Ein cyf/Our ref: CAS-279105-P9S5
Eich cyf/Your ref: 25/0289

BWRIAD/PROPOSAL: PARTIAL DISCHARGE OF CONDITION 4 (WATER QUALITY MONITORING) (IN RELATION TO THE BUSINESS PARK AREA ONLY) OF 16/1295 DISCHARGE OF CONDITION 01 (RESERVED MATTERS) AND PARTIAL DISCHARGE OF CONDITION 07 (LANDSCAPE MANAGEMENT PLAN) FOR NEW SURFACE WATER DITCH ASSOCIATED WITH PLANNING PERMISSION 06/0471 FOR REDEVELOPMENT OF SITE TO CREATE A MIXED USE URBAN EXTENSION

LLEOLIAD/LOCATION: LAND EAST OF PHASE 5 GLAN LLYN DEVELOPMENT SITE MONKS DITCH DRIVE ST MODWEN PARK NEWPORT SOUTH WALES

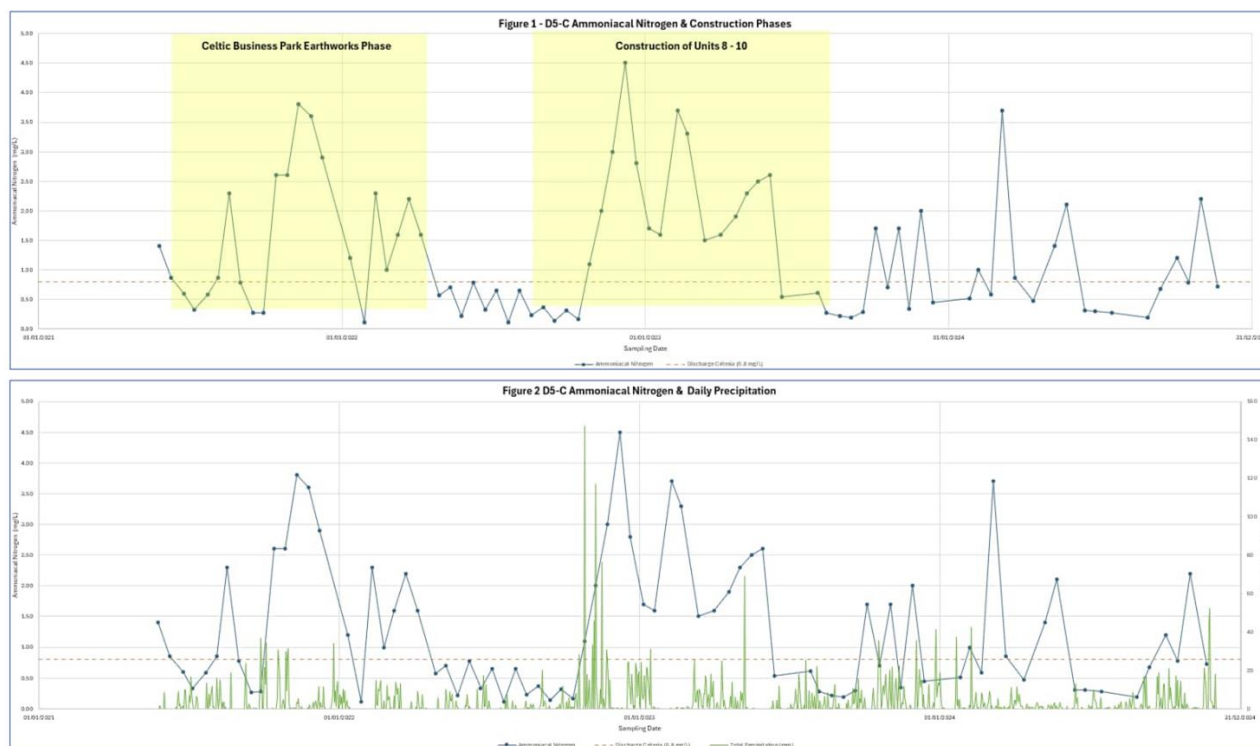
As part of the permit application, monitoring from D5-C (a mid-point reen location) was undertaken fortnightly between May 2021 and December 2024. The results for ammoniacal nitrogen, for example, have been included in Figure1 and Figure2 of the 'Surface Water Quality Summary', and have been presented below for reference. The data shows that circa 50% of the time, the compliance limit of 0.8 mg/l is breached; this is evident during the earthworks phase, construction of Unit 8-10 phase and the subsequent 18 months.

Our interpretation is that the data does not indicate conditions have considerably improved over time. Although we recognise this may have been exacerbated during the earthworks / construction, we note post completion of the construction of Units 8-10, 10 out of 26 samples continue to breach the compliance criteria.

The narrative apports these concentrations to natural sources, as a result of vegetation die back and subsequent release of ammoniacal nitrogen into the watercourse. However, it has previously been evidenced from geo-environmental data that ammoniacal nitrogen is a key Contaminants of Concern within soils and groundwater and is ubiquitous across the site – this was anthropogenically introduced during the site's historical usage as a steelworks. It is therefore likely that the persistent concentrations of ammoniacal nitrogen within the reen system is as a result, in part at least, of impacted groundwater entering the reens.

We therefore are unable to recommend with discharge of condition and advise that water quality monitoring within the reëns should continue until the remediation works across the commercial areas have been sufficiently validated (and signed off through discharge of Condition 27 and 28) and water quality monitoring within the reëns is compliant.
